## **Amendments to the Drawings**

The attached sheets of drawings includes changes to Figs. 2-4, 7, 10, 12-14. These drawing sheets replace the original sheets including Fig. 2-4, 7, 10, 12-14.

USSN 09/924,294  
Replacement Sheet

FIG. 14

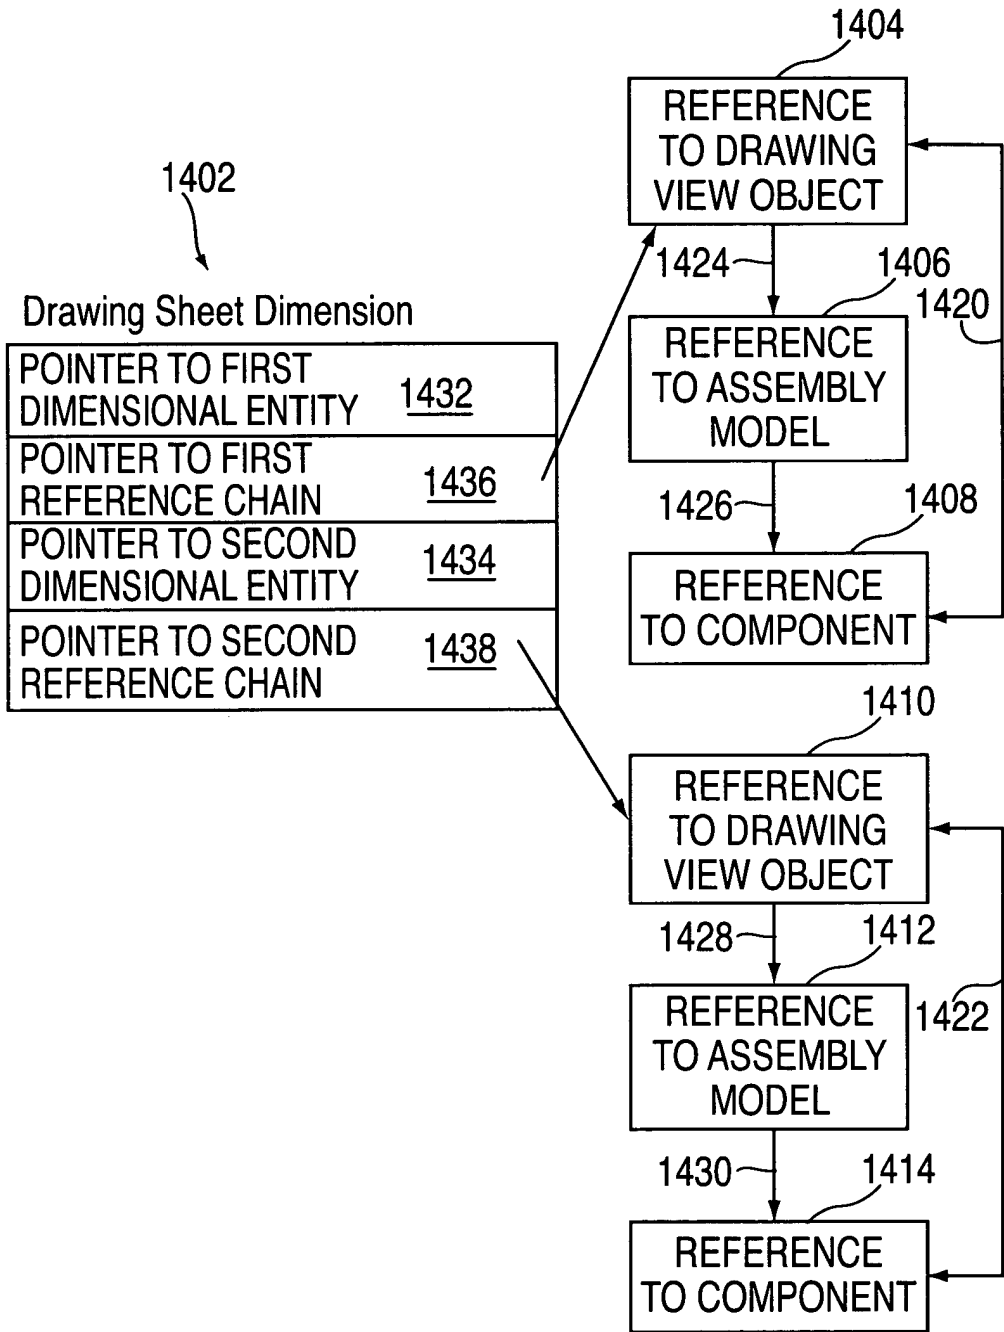
In Fig. 14, a connecting arrow has been corrected.
